UNITED STATES PATENT AND TRADEMARK OFFICE

APPLICATION NO.	FILING DATE	FIRST NAMED INVENTOR	ATTORNEY DOCKET NO.	CONFIRMATION NO.
09/589,881	06/09/2000	Jeongmin Moon	3430-0105P	1734

Office Action Summary	Application No. 09/589,881	Applicant(s) MOON, JEONGMIN	
	Examiner HOAN C. NGUYEN	Art Unit 2871

DETAILED ACTION

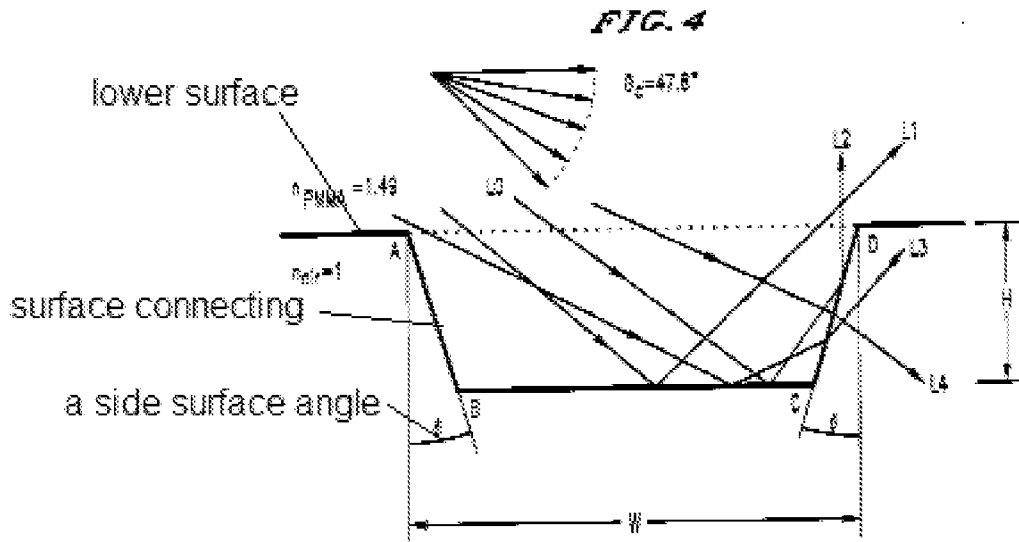
In regard to claims 1 and 2, Shinji et al. (Figs. 1 a-15b) disclose an auxiliary light source device comprising:

- a light source 1;
- a light reflecting member (reflector 4) which guides light from the light source into the light directing member,
- a light directing member 3 for directing incident light from the light source toward the reflector, with this structure of the light directing member 3, the light ray L4 can be outwardly along an orthogonal direction if L4 strikes the convex portion at different angle (see Examiner Answer mailed on 6/01/2005, Reply Brief Note mailed on 6/14/2006 and 11/20/2006).

- the light directing member including
 - a lower surface having a plurality of convex portions extending from the lower surface, each of the convex portions having a substantially planar surface which is substantially parallel to the lower surface, and a side surface angle δ between the lower surface and a surface connecting the planar surface of the convex portion is about 90° since a side surface angle $\delta = 0^\circ$ or 2° (col. 7 lines 5-6).

- the plurality of convex portions have the same side surface angle δ with each other.
- light reflected along an orthogonal direction L2/L3 to the liquid crystal display device is uniform (to emit primary light inputted from the side end plane of the

light guide uniformly, in abstract and col. 1 lines 27-28) according to Figs. 5 ($\delta = 0^\circ$) or Fig. 6 ($\delta = 2^\circ$) or Fig. 7 ($\delta = 5^\circ$).

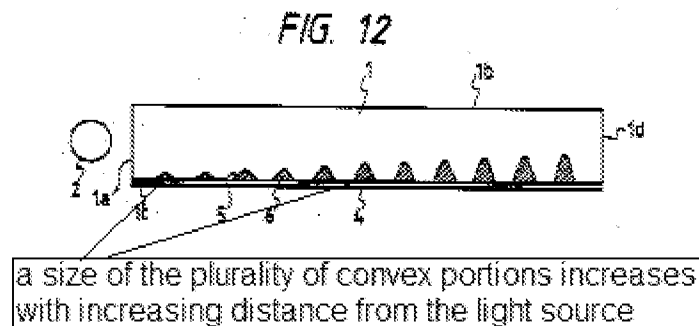
In regard to claims 8 and 17, Shinji et al. (Fig. 1 d or 1 g) disclose the plane surface of the plurality of convex portions has a bar shape extending perpendicular to a direction of light propagation in the light directing member 11 and along substantially an entire width of the reflective LCID device.
